BOUNTIFUL CITY
PLANNING COMMISSION AGENDA
Tuesday, May 7, 2019
6:30 p.m.

Bountiful City
Planning Commission Minutes
April 16, 2019
6:30 P.M.

Commission Staff Report

Subject: Public Hearing- Zone Map Amendment from C-G/PUD and MXD-PO to MXD-R

received
 4-11-19

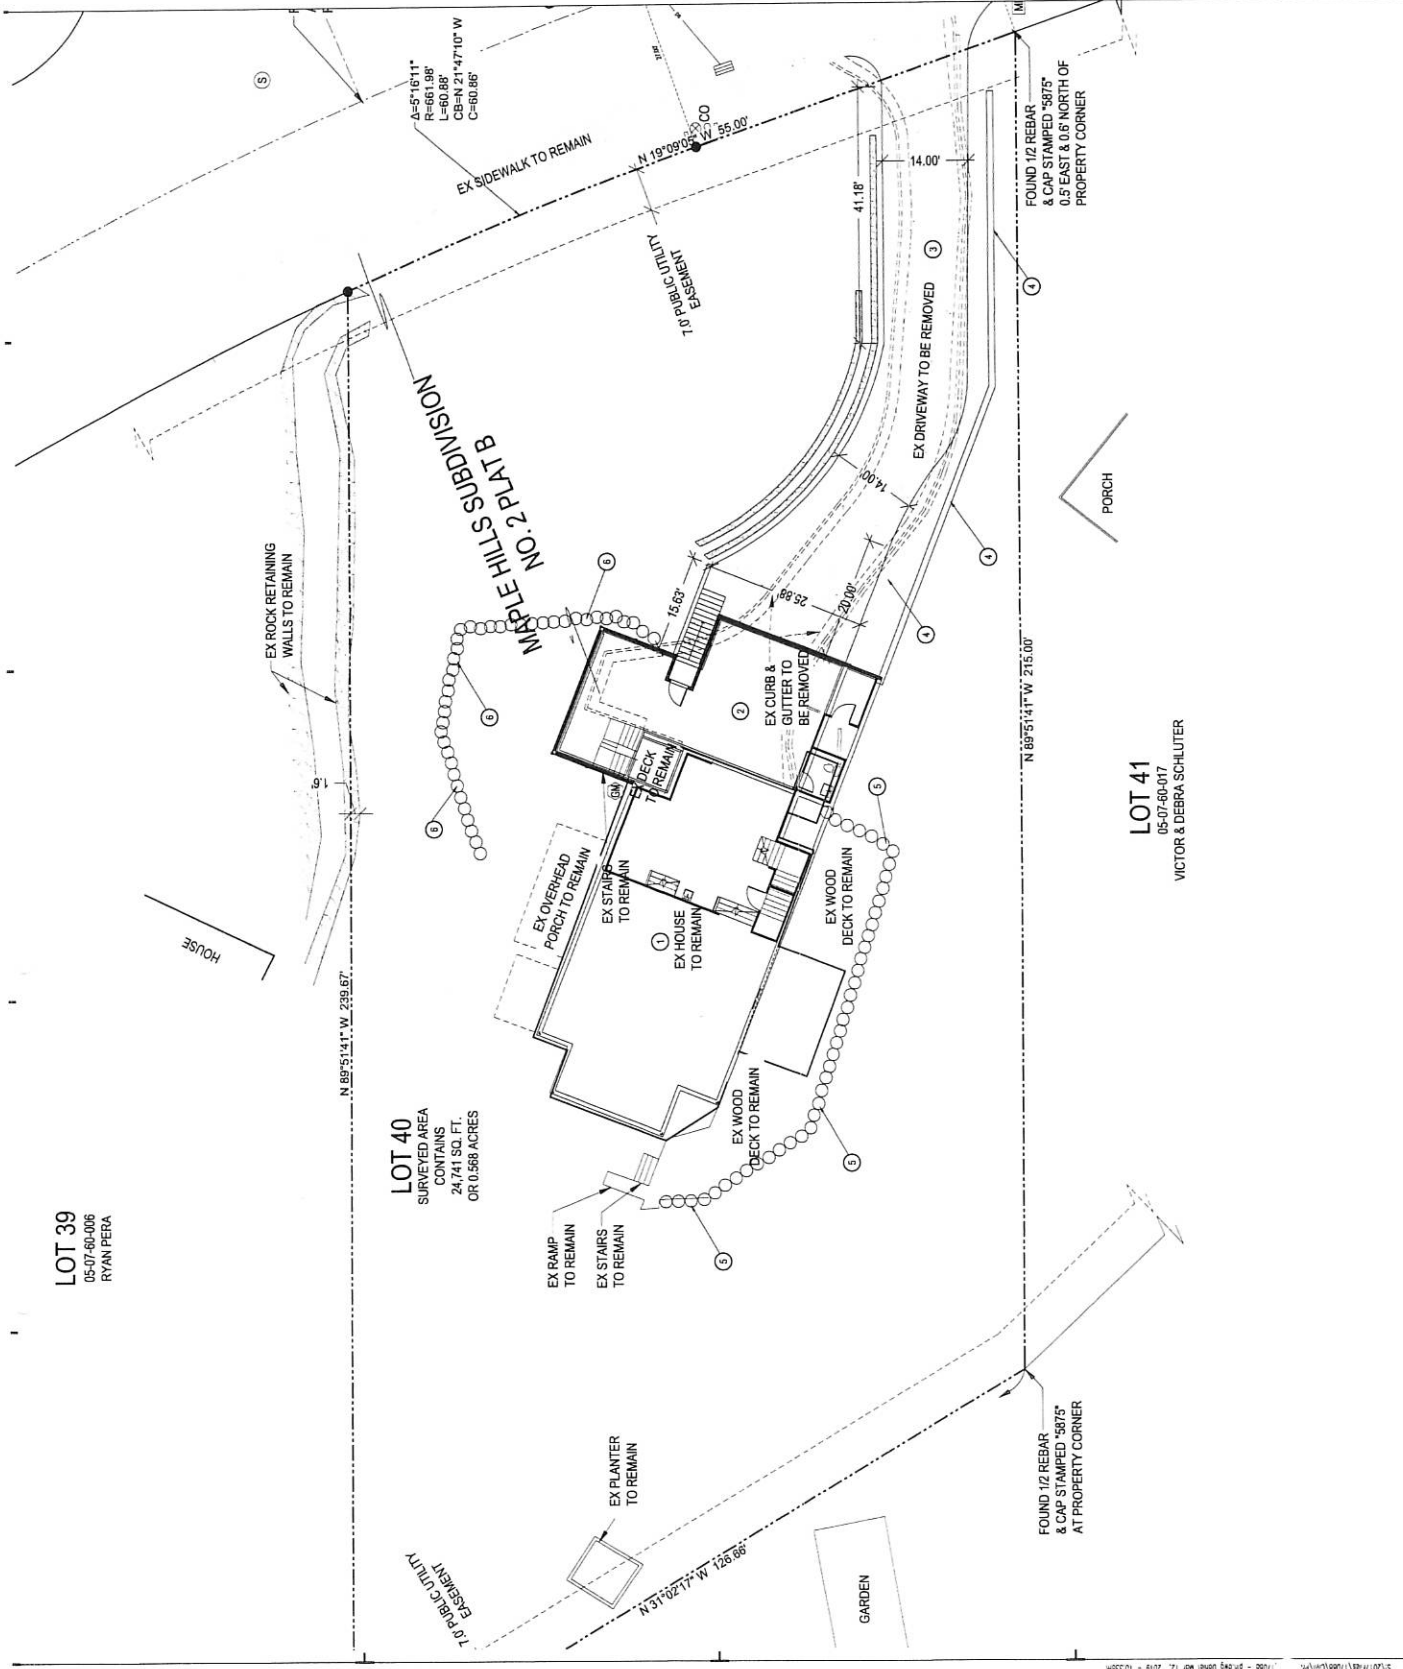
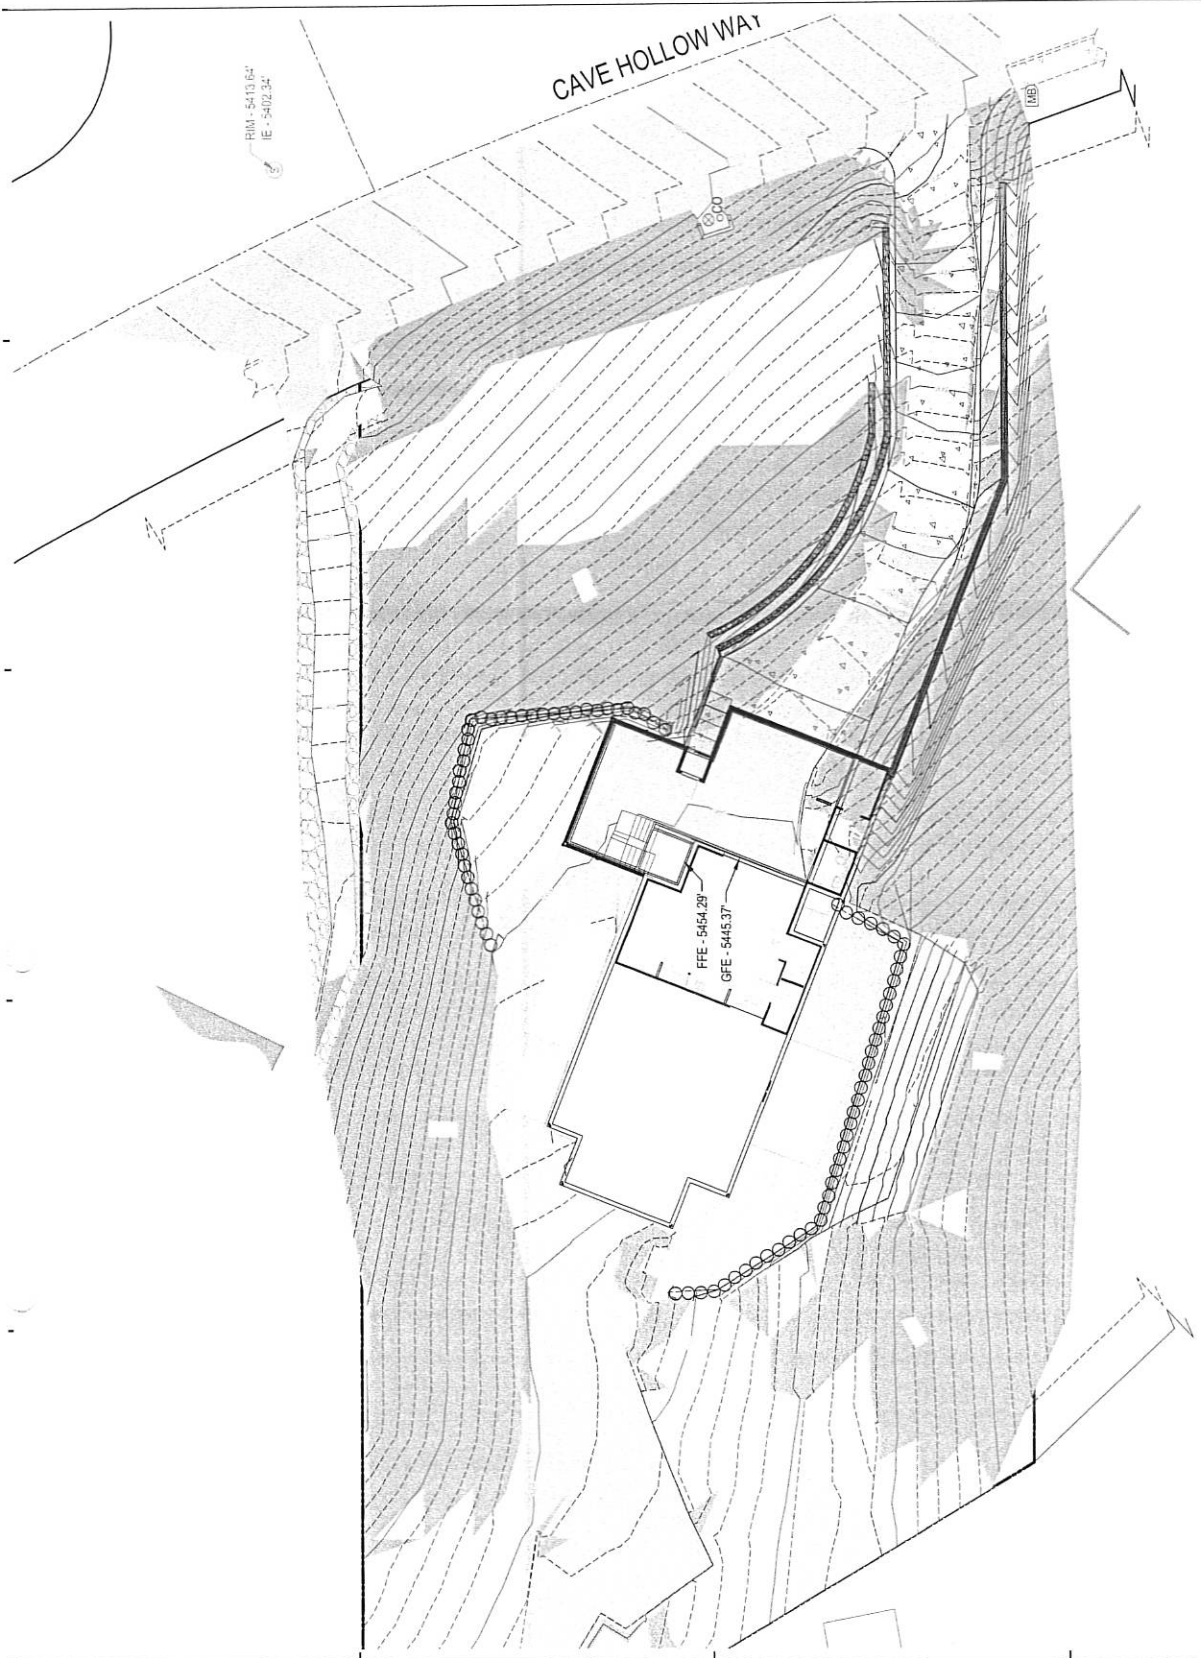
The current proposal has a similar, but smaller three-car garage along with living space for the proposed addition. The width of the driveway has been decreased, the hammerhead turnaround at the top of the driveway has been removed and the tall retaining wall has also been removed from the revised plan. Despite these changes the impact on steep slope areas of the property is not considered minimal by staff, as there would be significant cuts, fills and retentions which would need to occur.

Staff has recommended to the applicants any expansion of their home should be into areas of their property where the steep slopes have previously been disturbed and not create new disturbances. The proposed plans do not fully comply with those recommendations.

Staff Response: Many of the properties in the R-F zone have similar constraints as the applicant’s property which limit the buildable area and require steep narrow driveways. While there may be an appropriate disturbance to the slope to enable construction of a less steep driveway, the current proposal would not be considered the minimum disturbance necessary to accomplish this objective.

Staff Response: The original approval was consistent with the development standards in the R-F zone, and allowed for use of the property. The applicant has not demonstrated other reasonable or feasible alternatives with less impact to the slope areas.

Staff Response: The purpose of the land use ordinance that requires improvements be located on slopes less than 30% and retaining walls less than 10 feet tall is to preserve the hillside and manage runoff and erosion on properties located in the foothills. The proposed variance disturbs the slopes beyond the minimal amount necessary. Any variance proposal requesting to disturb the steep slopes on a property should be minimized as much as possible.

Staff recommends the Planning Commission review the criteria required for approval as outlined in State Law to determine if the applicants have sufficiently met all of the requirements necessary for approval of the requested variance.
